TUNNEL CORRIDOR ACCESSIBILITY ASSESSMENT

Cook County Department of Corrections Campus

April 01, 2024

TUNNEL CORRIDOR RAMP ACCESSIBILITY ASSESSMENT
COOK COUNTY JAIL CAMPUS

RTU North Tunnel Corridor – LiDAR Scan Images

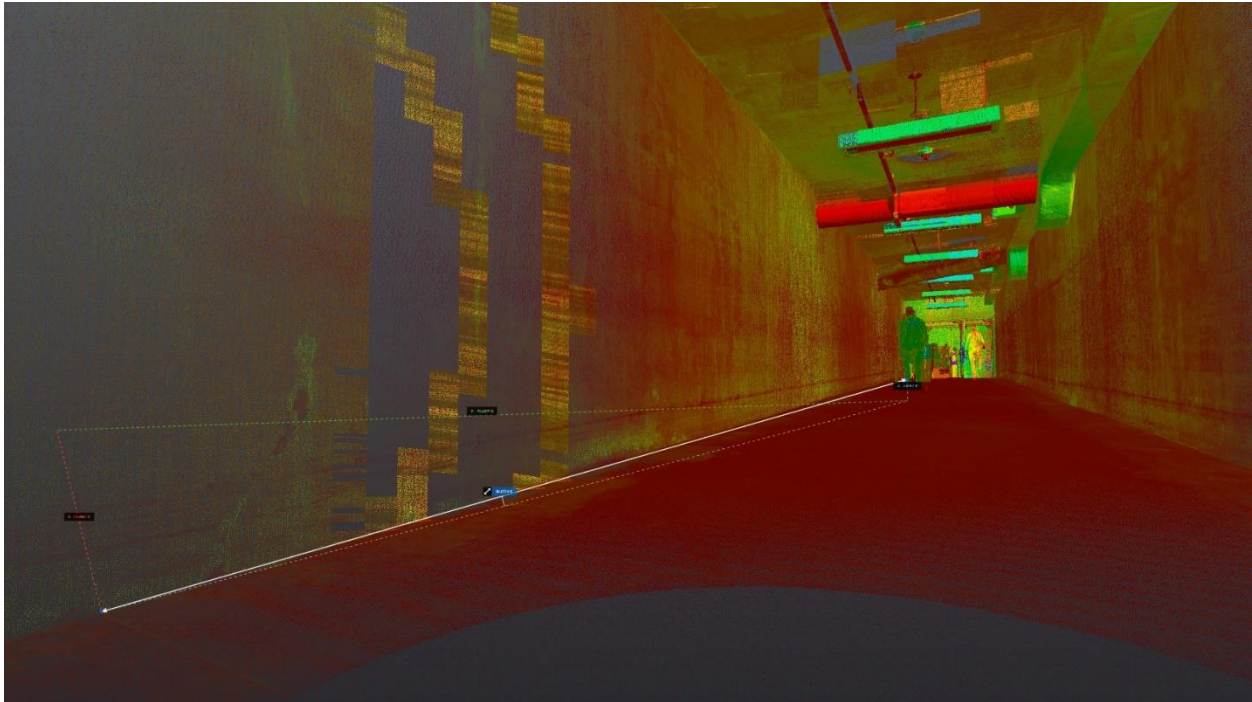
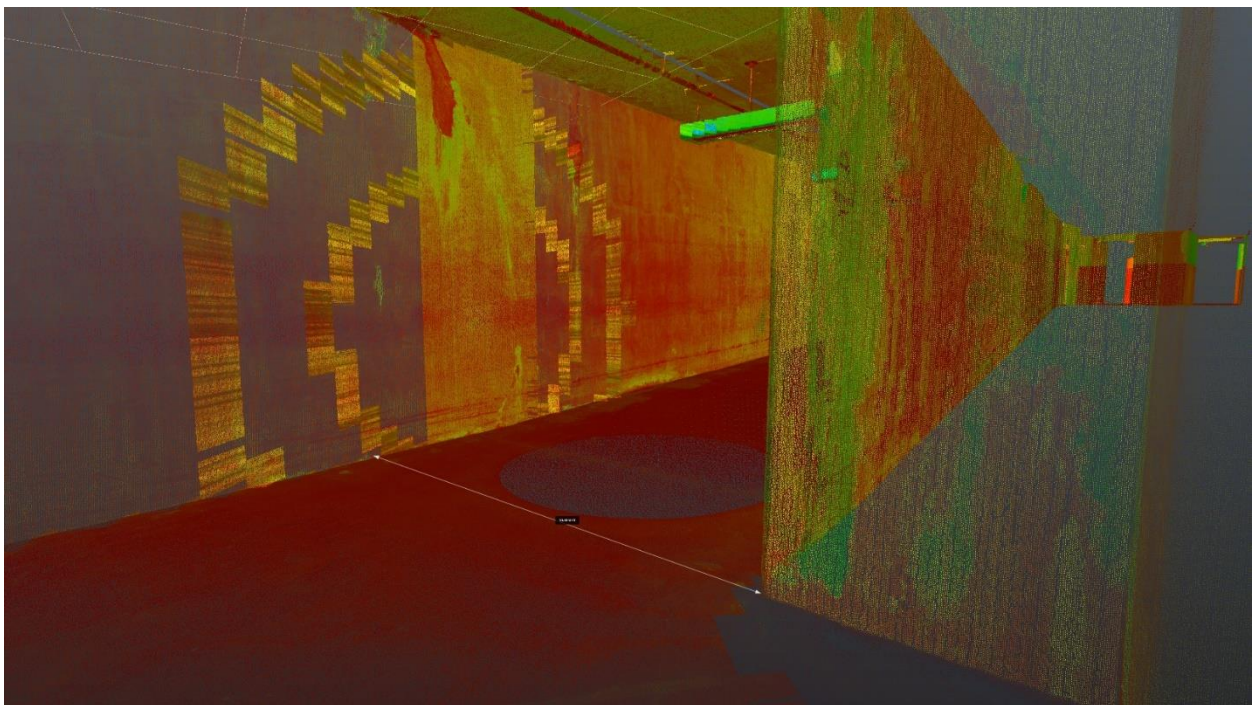
The slope floor surface at the North Corridor has an 83.9 feet horizontal run and a 2.7-foot vertical rise. The inclined floor surface is less than (shallower) 1:31 slope overall.

From the ADA regulations excerpts listed above the applicable excerpt is line-item no. 1. By definition, a ramp is a walking surface that has a running slope steeper than 1:20. Since the Corridor floor surface has less than a 1:20 slope, it is not a ramp. Consequently, ADAAG regulations related to ramps do not apply here.

The North Corridor Tunnel is in compliance with ADA and other code requirements for accessibility.

Length: approx. 84' Rise: approx. 2.7' (32.33") Slope: approx. 1:31

RTU East Tunnel Corridor – LiDAR Scan Images

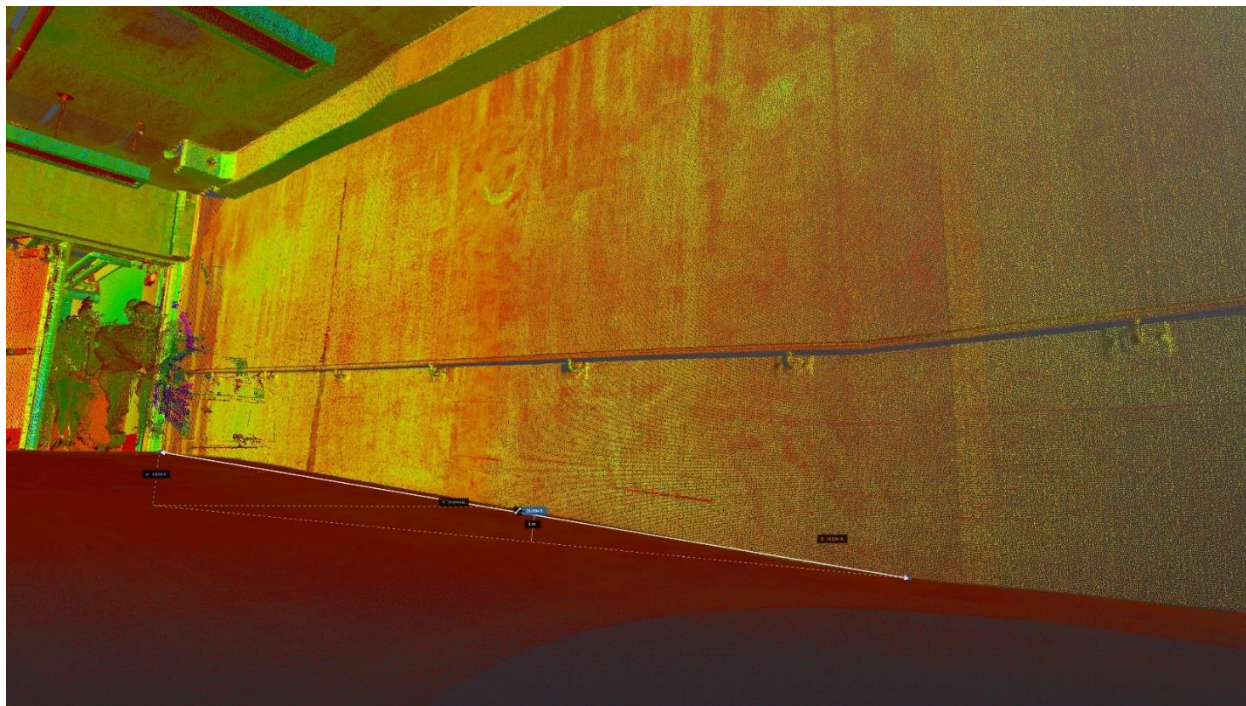
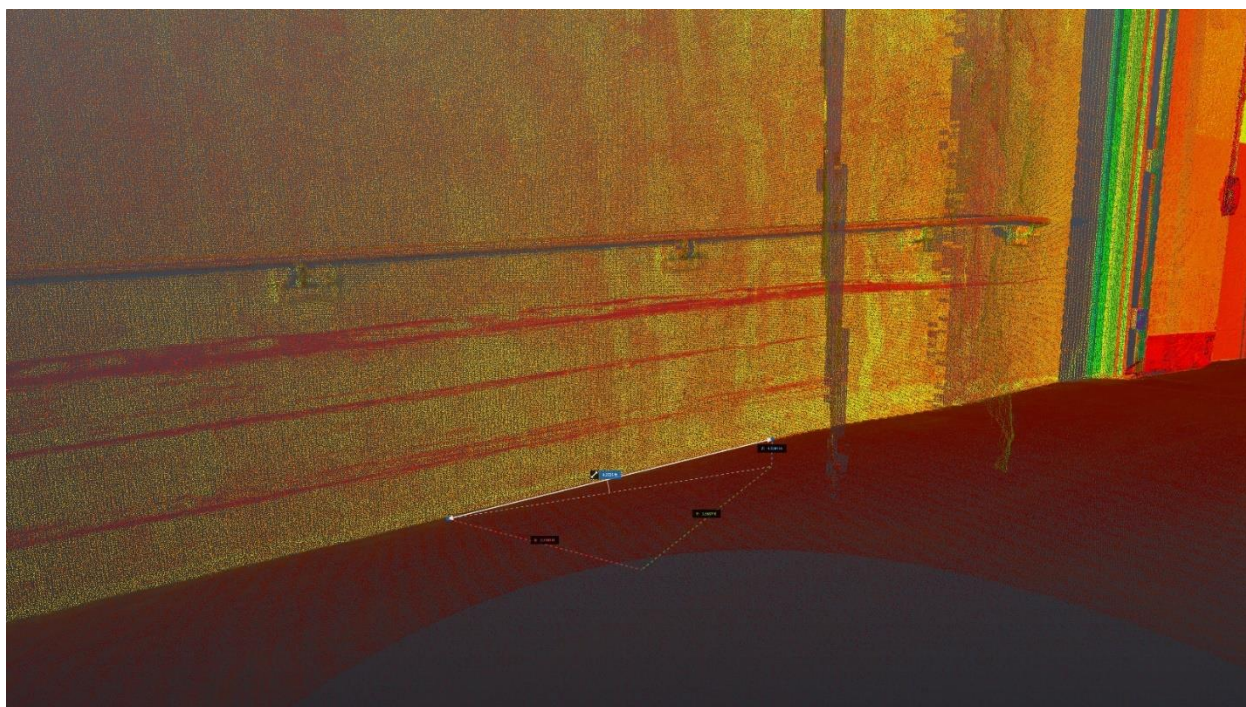
2. **Upper Ramp:** The Upper Ramp has a 25.95' horizontal run and a 1.93' vertical rise with an average slope of 1:13.4. There is a variation in slope at the very top of the ramp. The last 4.27' of the run, at the top has a rise of 4.56" for a slope of 1:11.

The upper portion of the ramp floor surface is not code compliant; the top 16.5% of the overall length is approximately 0.64% steeper than permitted by code. Since the bottom portion of the ramp run is shallower than 1:12, it would be possible to add a floor topping which will even-out the slope make a consistent floor slope that has a 1:12 slope or shallower.

Top run length: approx. 25.95'

Rise: approx. 1.93' (23.16")

Slope: approx. 1:13.4

Steep slope at ramp top length: approx. 4.27'

Rise: approx. 4.56"

Slope: approx. 1:11

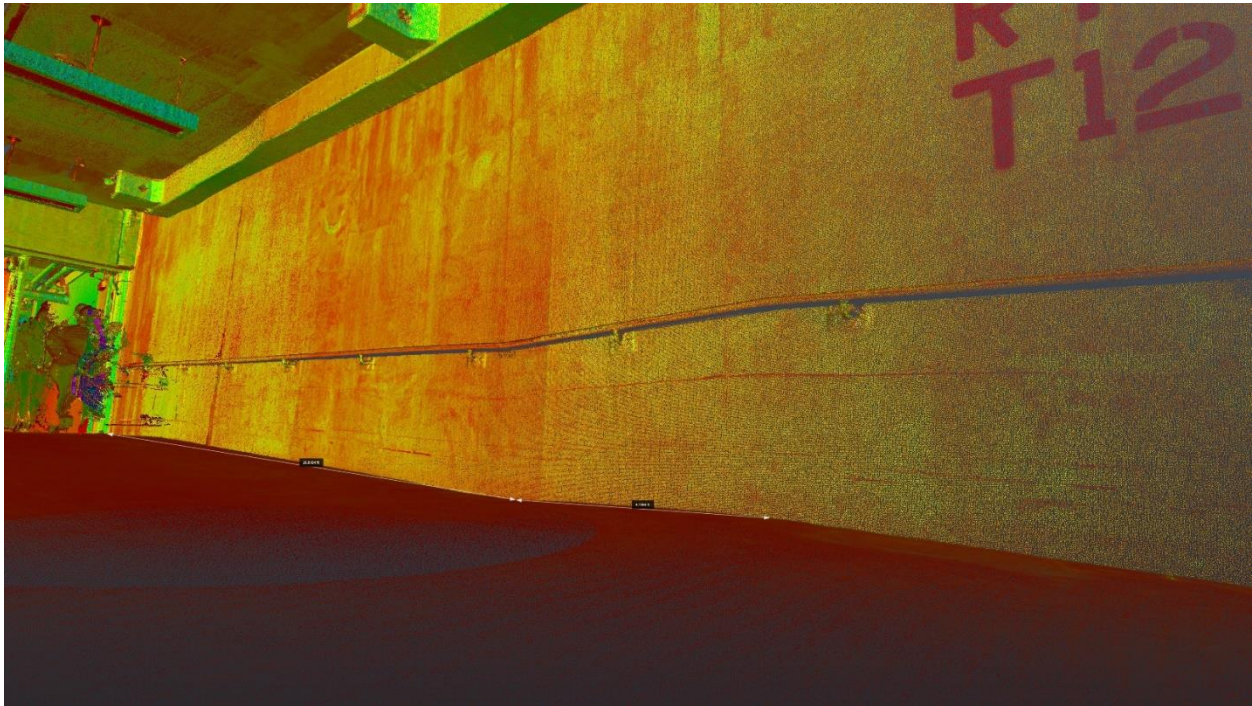
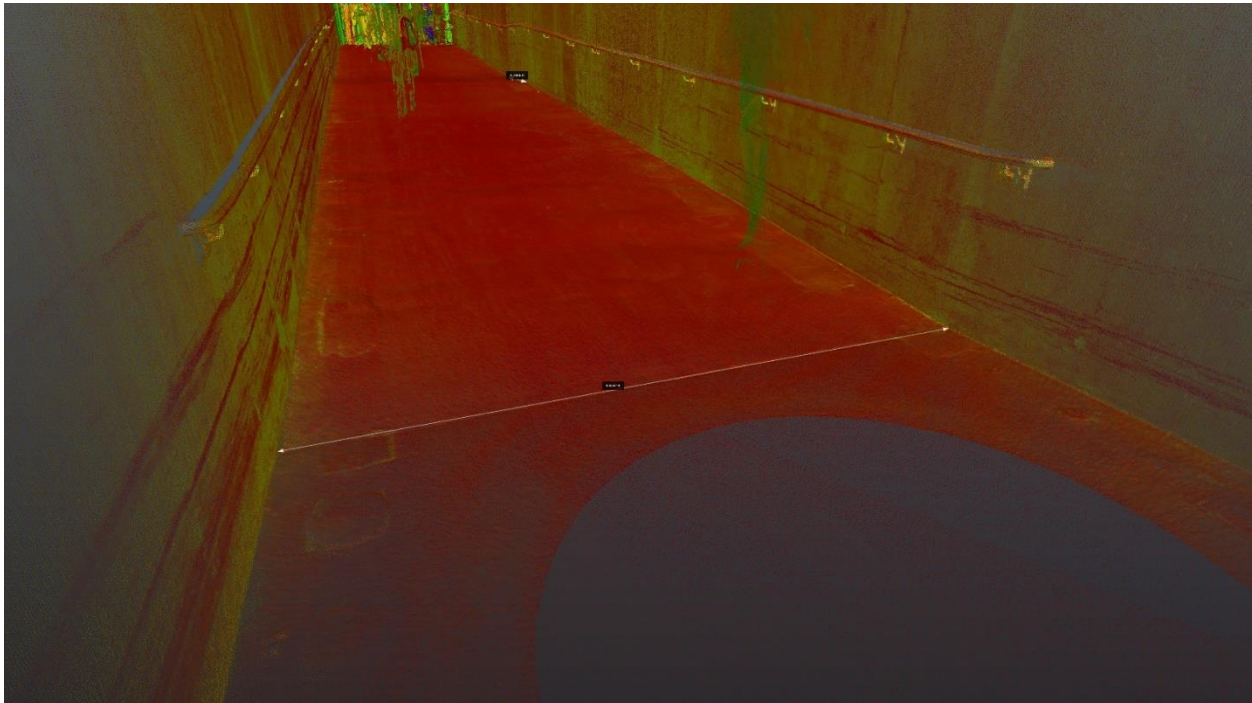
3. **Intermediate Landing:** The Intermediate Landing is 4.75 feet (57 in.) in length. Since the landing length is less than 60 inches in length, the Intermediate Landing is not code compliant.

It is 5% shorter than the required length. To correct this nonconformity, a longer level floor plane at the landing will need to be provided, extending the floor surface west. This will require the Lower Ramp to be rebuilt, along its entire length, to provide for the additional landing length and maintaining a maximum 1:12 ramp slope.

Landing length: approx. 4.75'

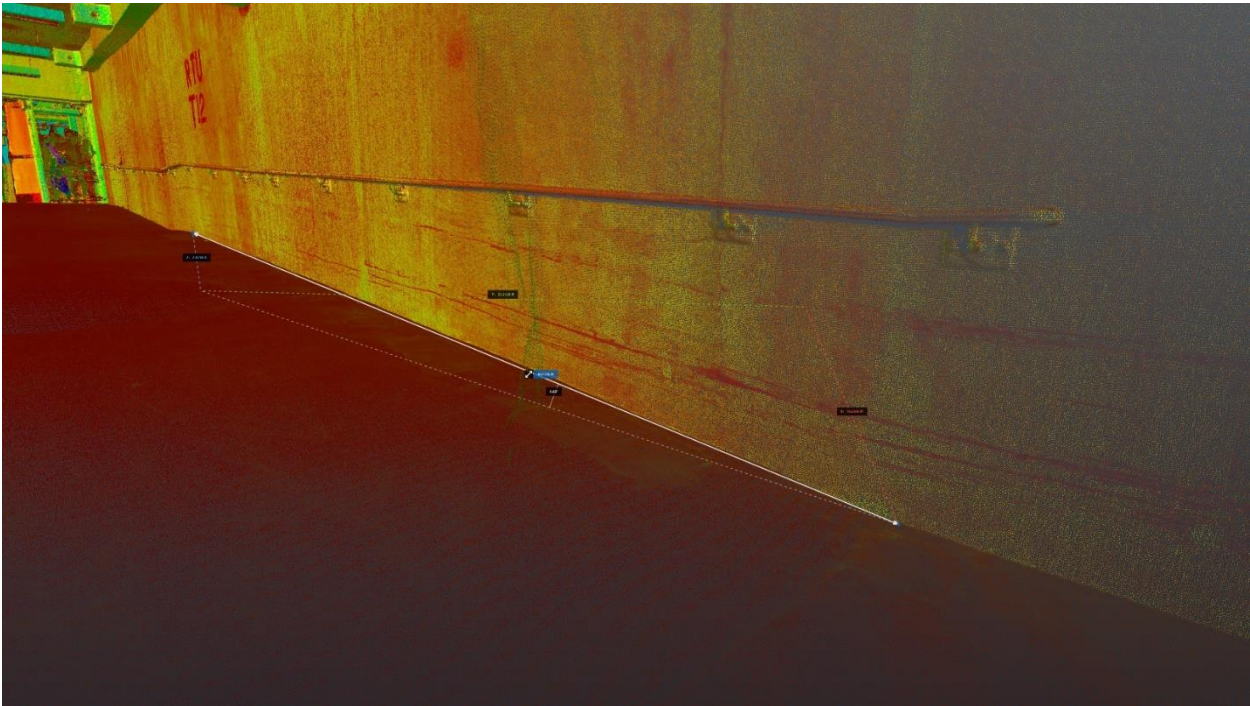
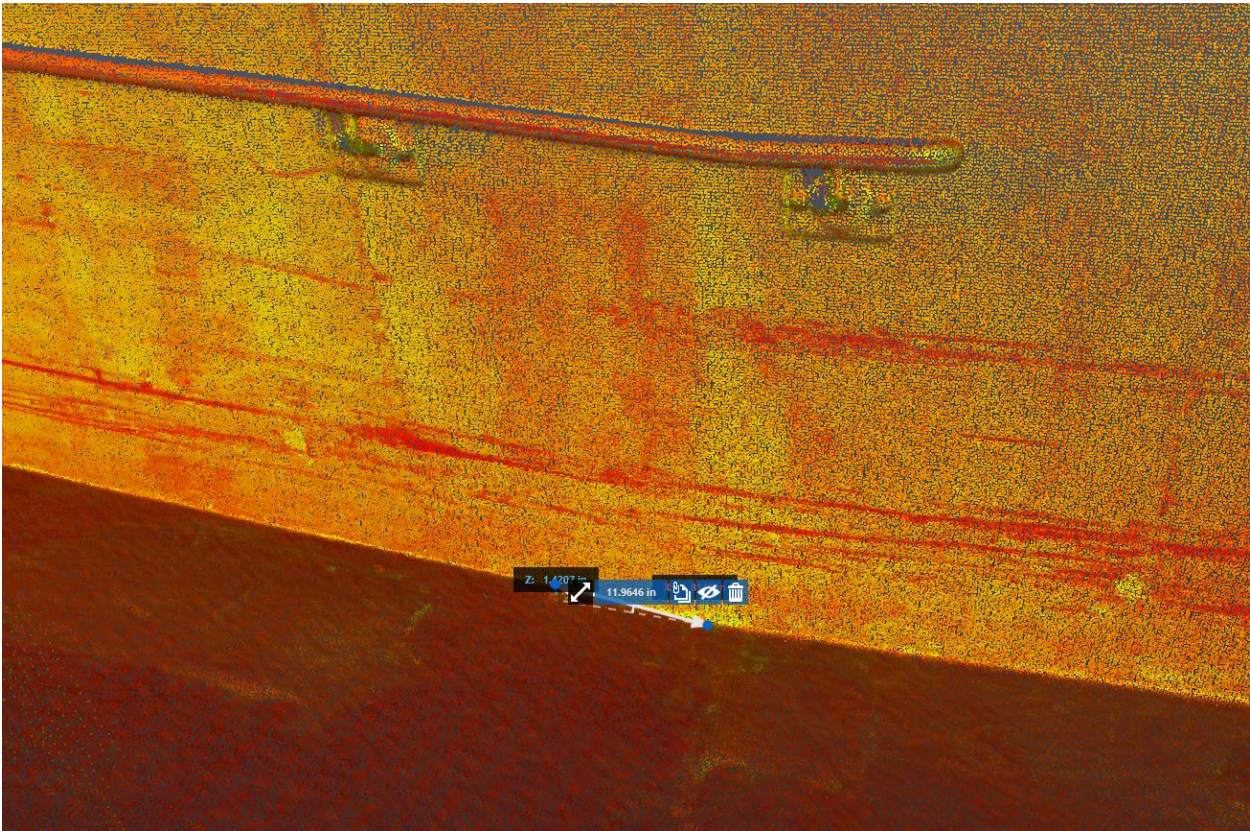
4. **Lower Ramp:** The Lower Ramp has a 30.4' horizontal run and a 2.47 vertical rise, with an average slope of 1:12. There is a variation in slope at the very bottom of the ramp. The last 1 foot of the run is steeper than the rest of the ramp with a slope of approximately 1:8.5.

The lower portion of the ramp floor surface is not code compliant; the lower 3.5% of the overall run is approximately 11.7% steeper than permitted by code. The floor surface will need to be feathered out, and the ramp length extended slightly for the Lower Ramp floor to be compliant with code requirements for ramp slope at this location.

Bottom run length: approx. 30.5' Rise: approx. 2.47' (29.7") Slope: approx. 1:12

Steep slope at ramp bottom length: approx. 1' Rise: approx. 1.42" Slope: approx. 1:8.5

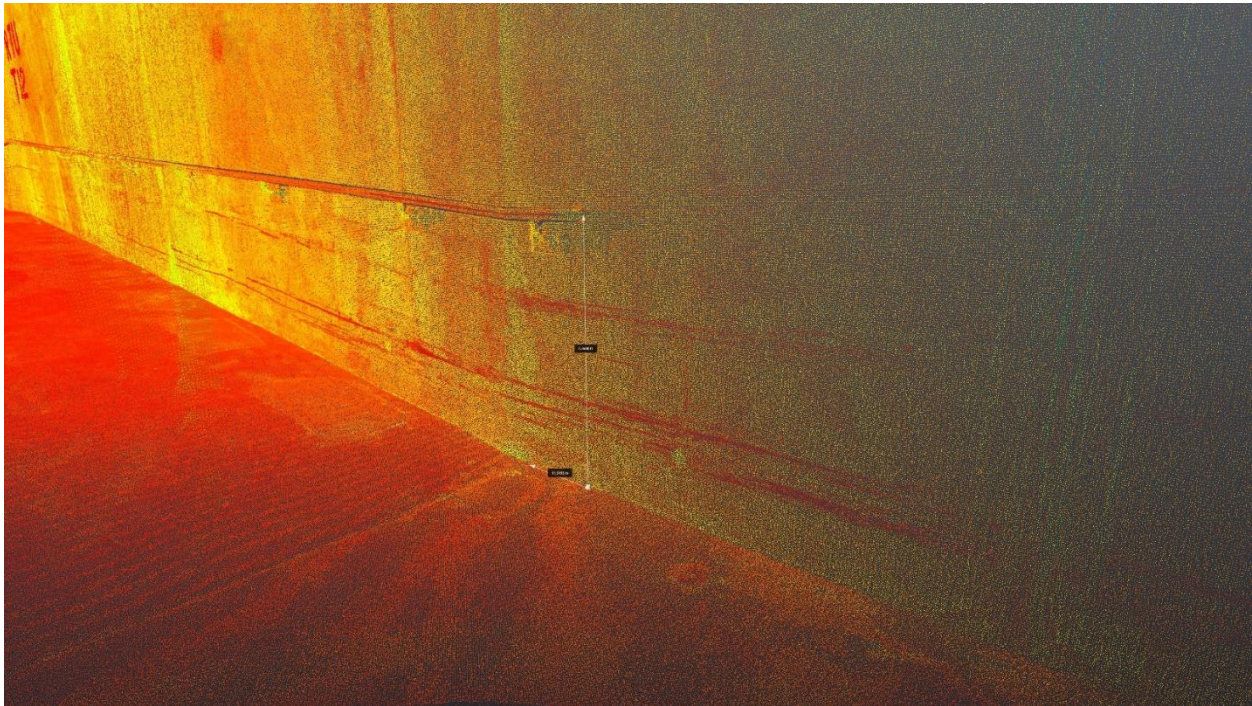
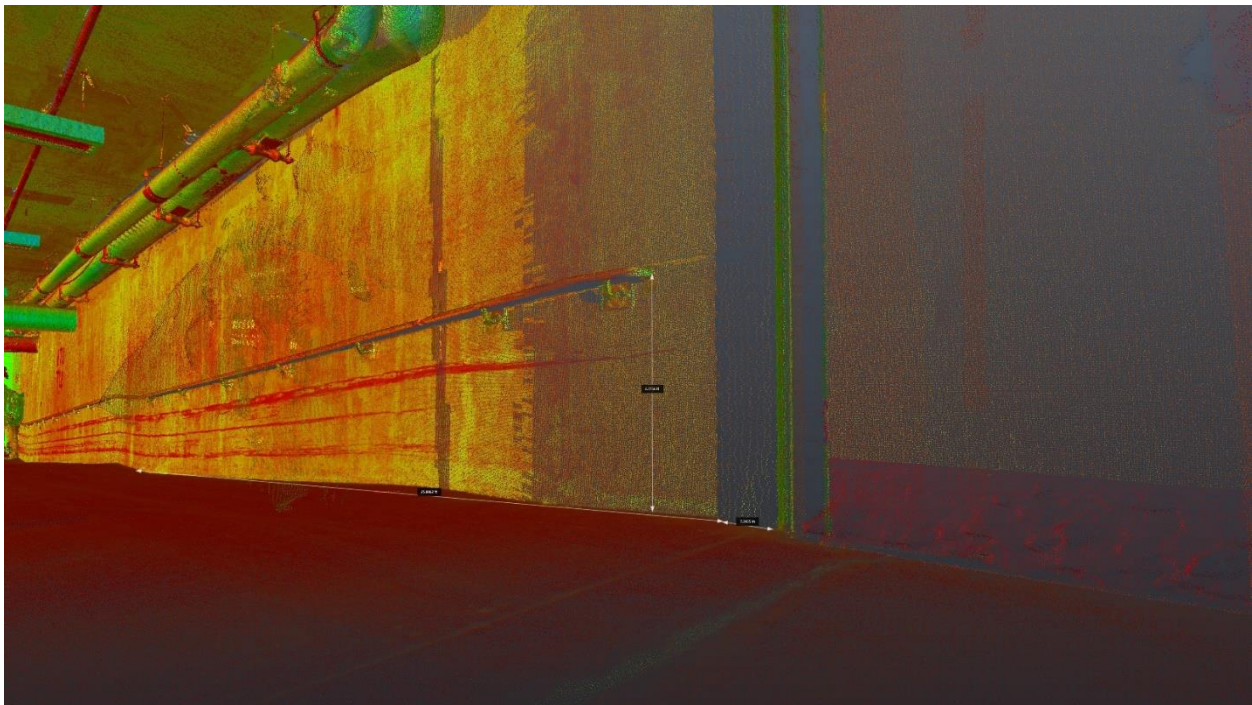
The handrails extend 7.4" beyond the Lower Ramp and 11.3" beyond the Upper Ramp. Since the handrail extensions are less than 12 inches, the handrails are not in compliance with code requirements for handrail extensions.

Ramp bottom handrail extensions: approx. 11.3"

Height: approx. 33.2."

Ramp top handrails do not extend full length of ramp, no extensions.

Top landing length: approx. 7.4"
